April 2024 | Final Environmental Impact Report  
State Clearinghouse No. 2023010229

# GRANT ELEMENTARY SCHOOL CAMPUS MASTER PLAN PROJECT

for Santa Monica-Malibu Unified School District

Figure 3-7b - Proposed Project Site Plan - Phase 2

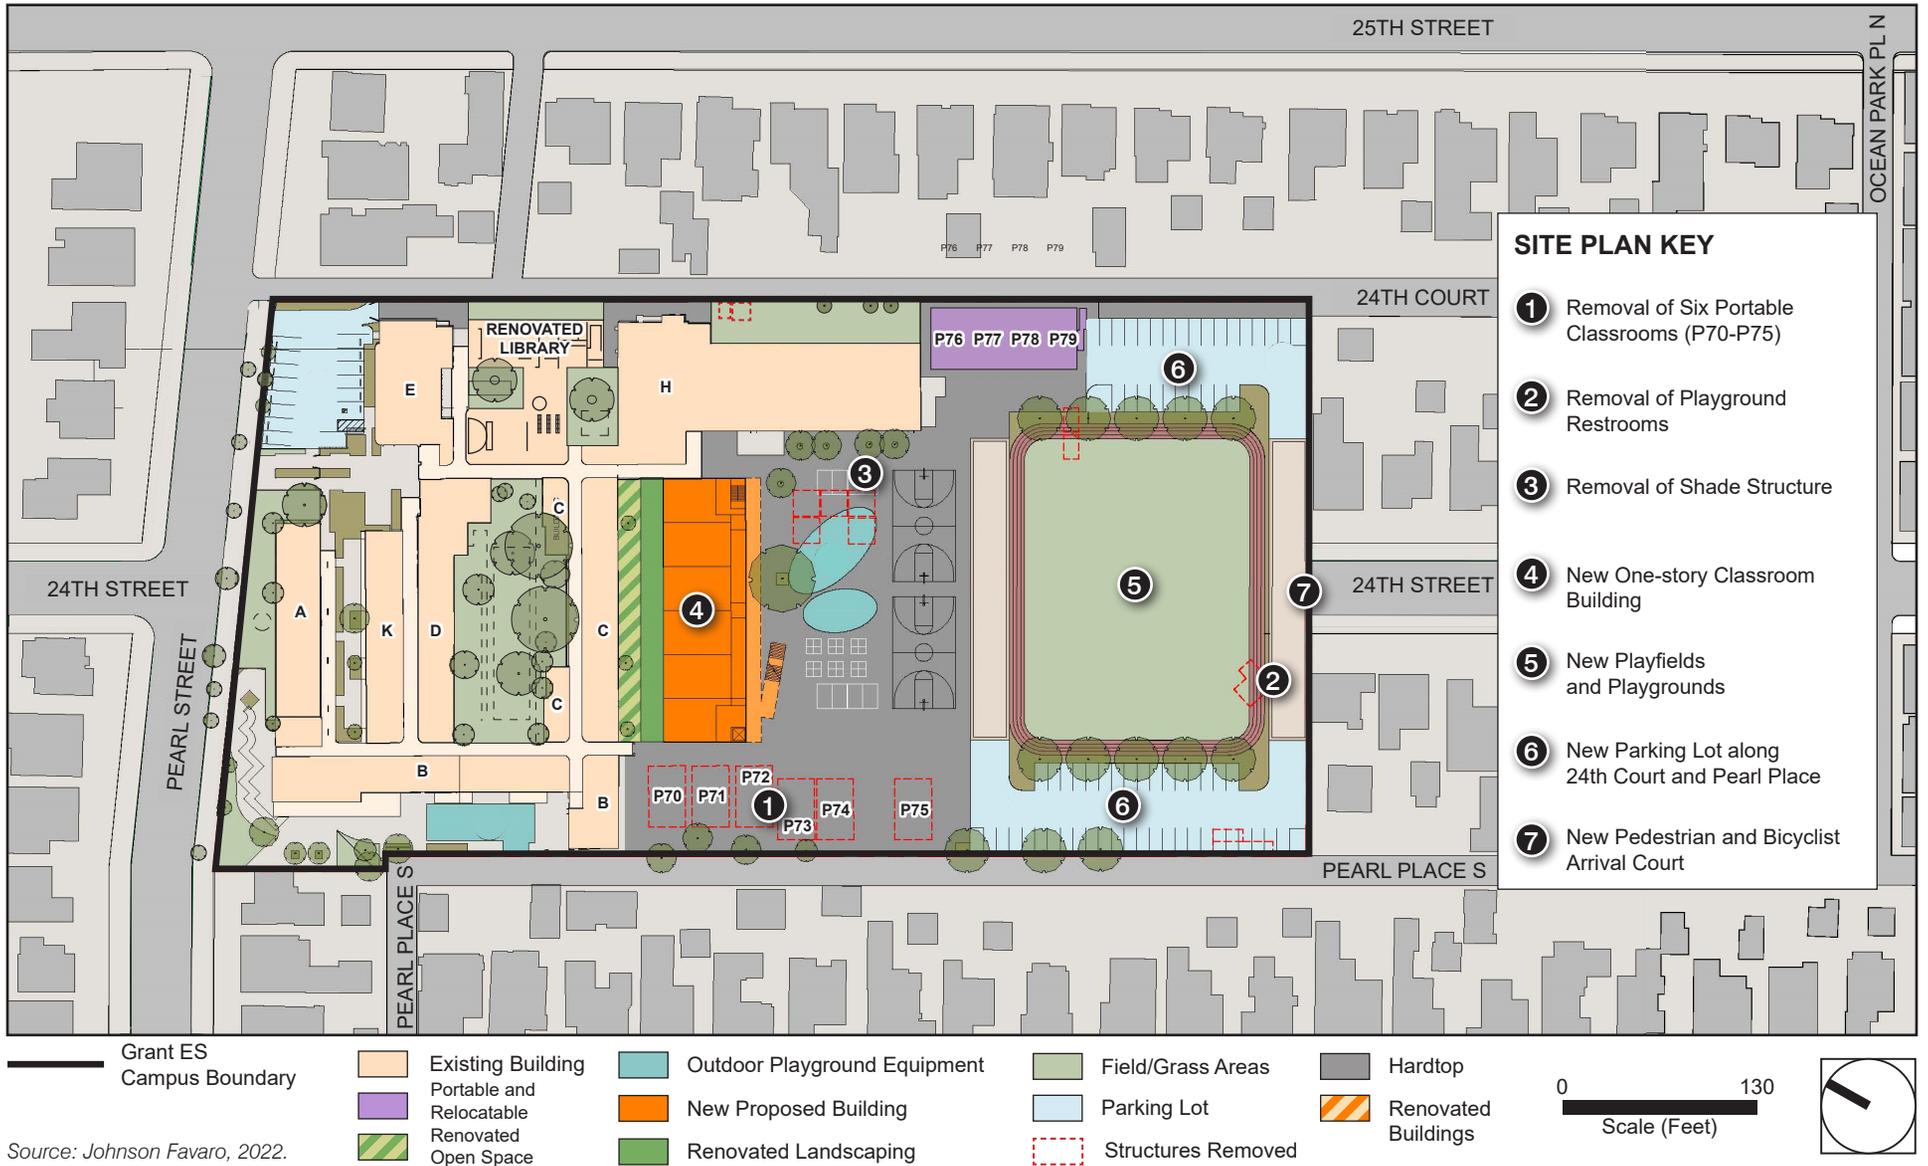
**Figure 3-7b.** *Proposed Project Site Plan - Phase 2* [Revised]

Figure 5.10-2 - Proposed Vehicular/Pedestrian Circulation

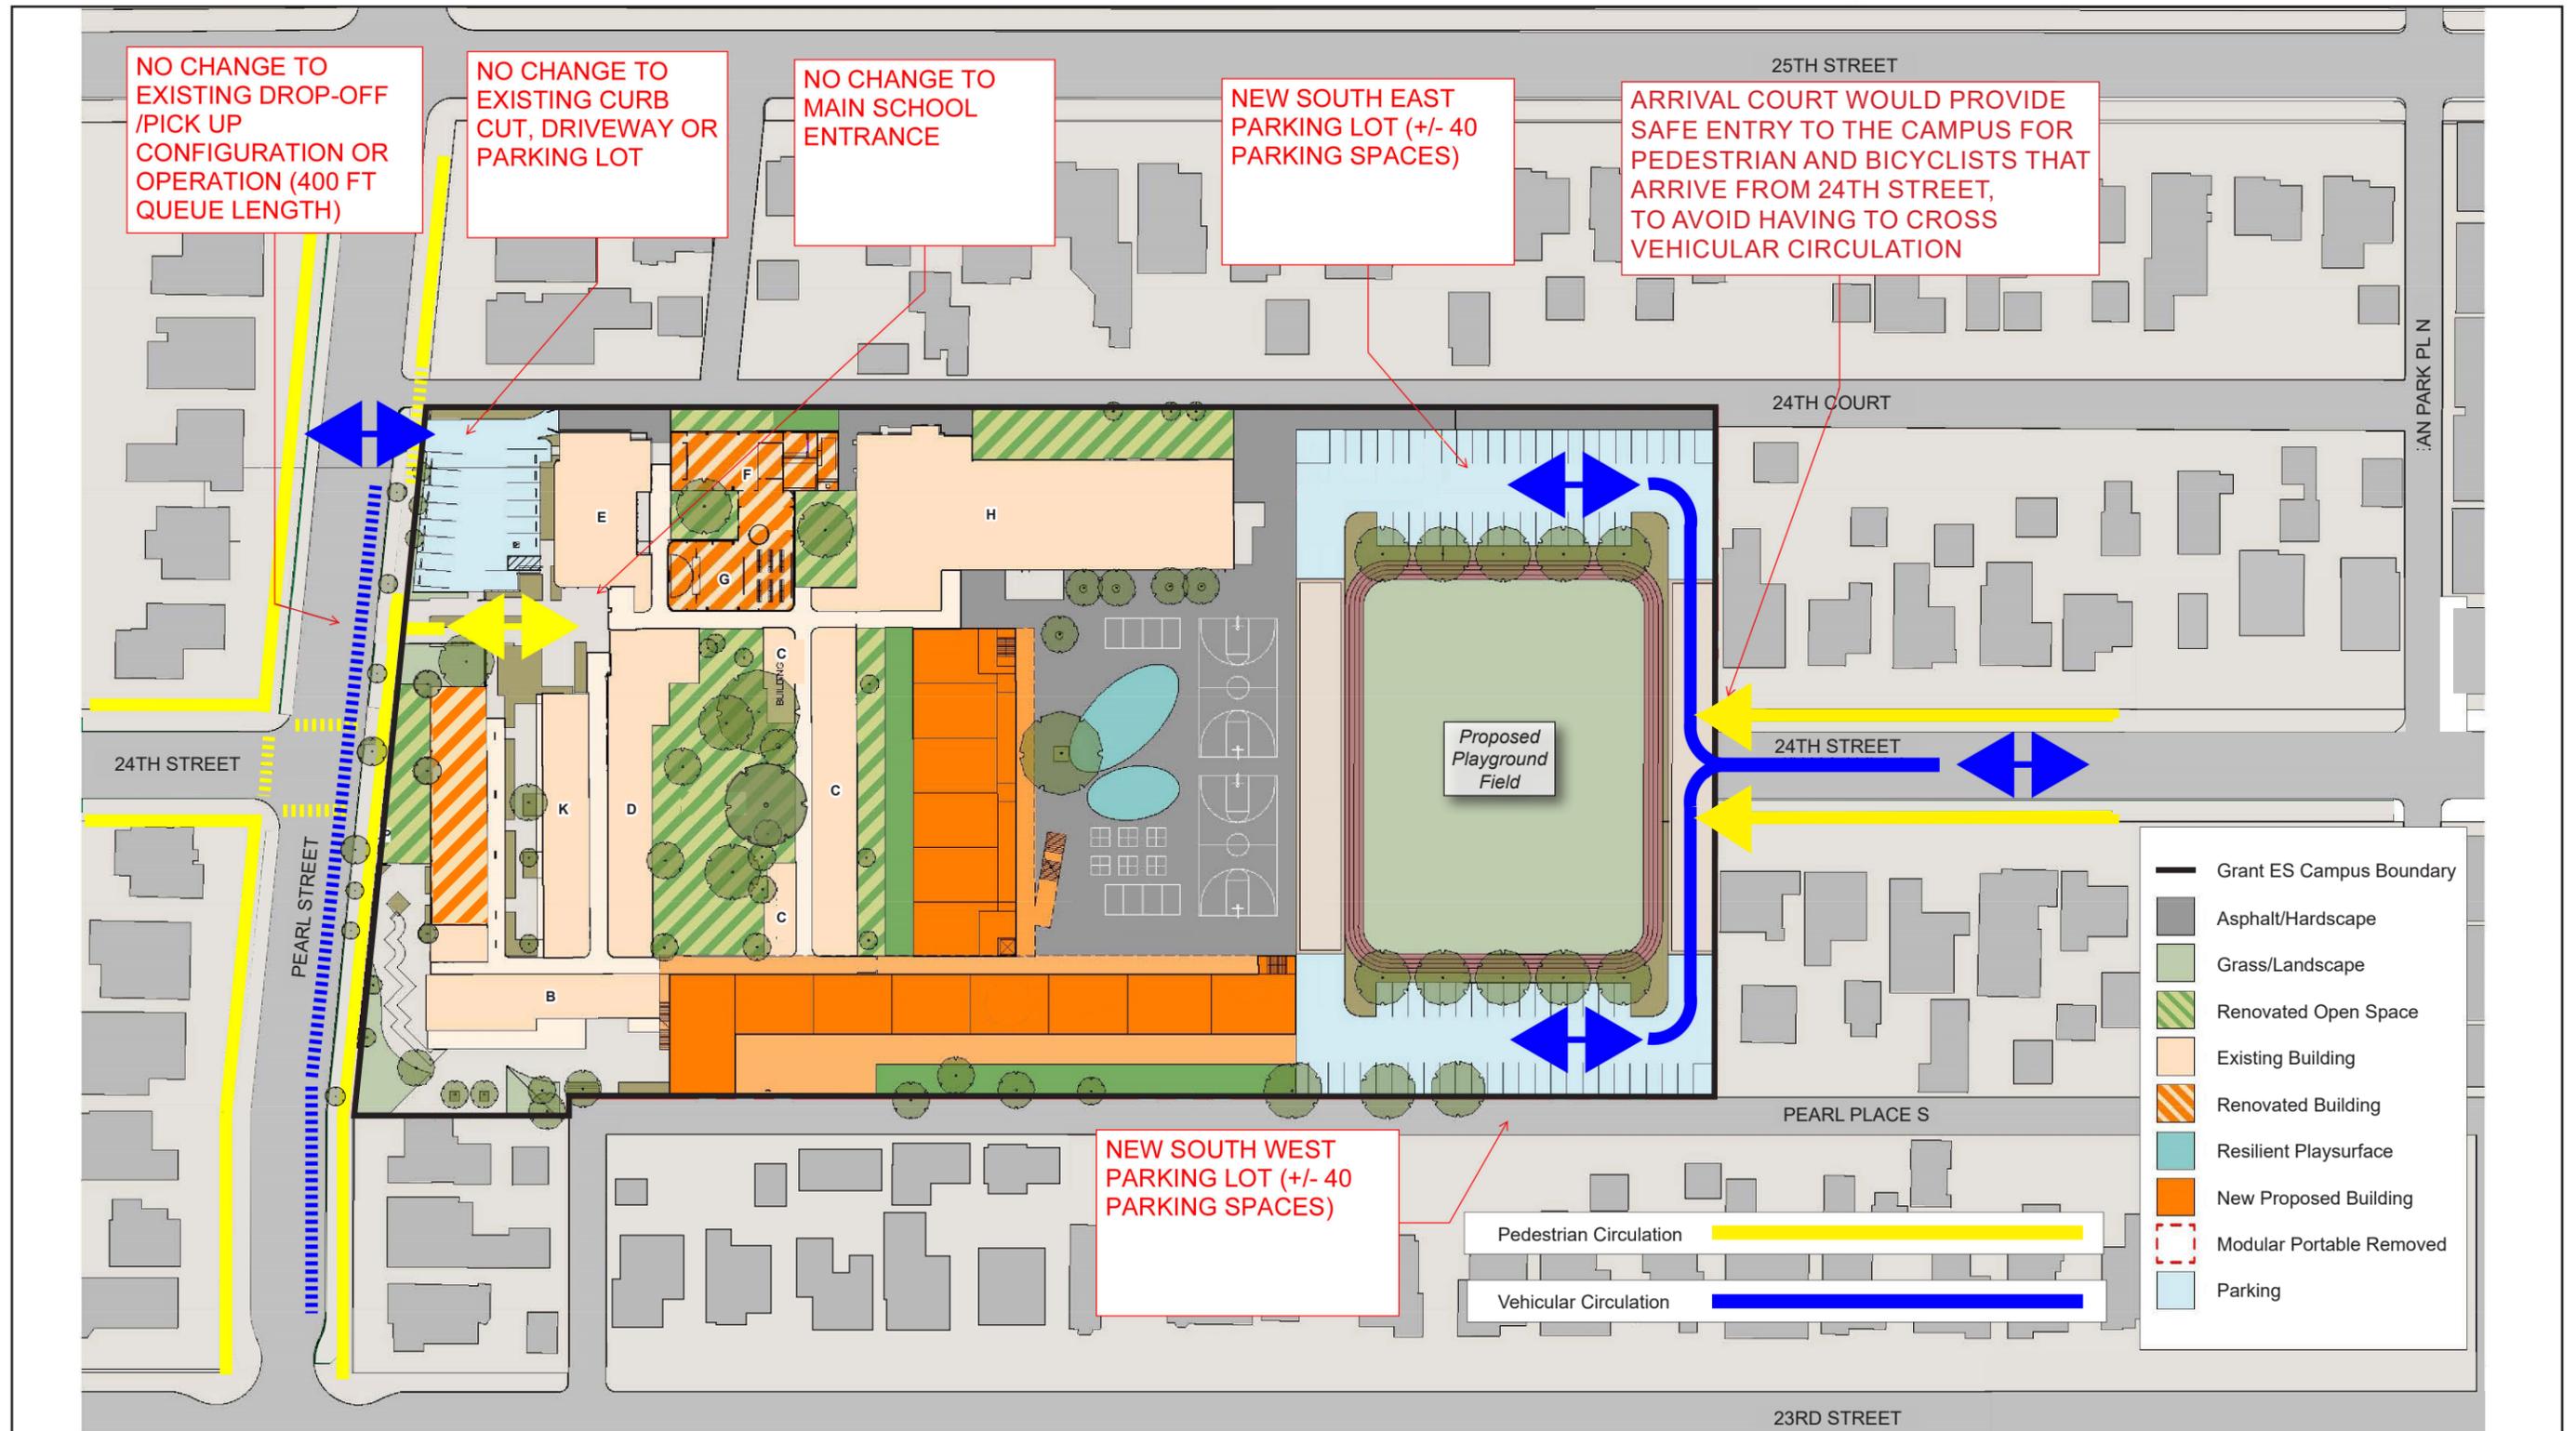
**Figure 5.10-2.** *Proposed Vehicular/Pedestrian Circulation* [Revised]
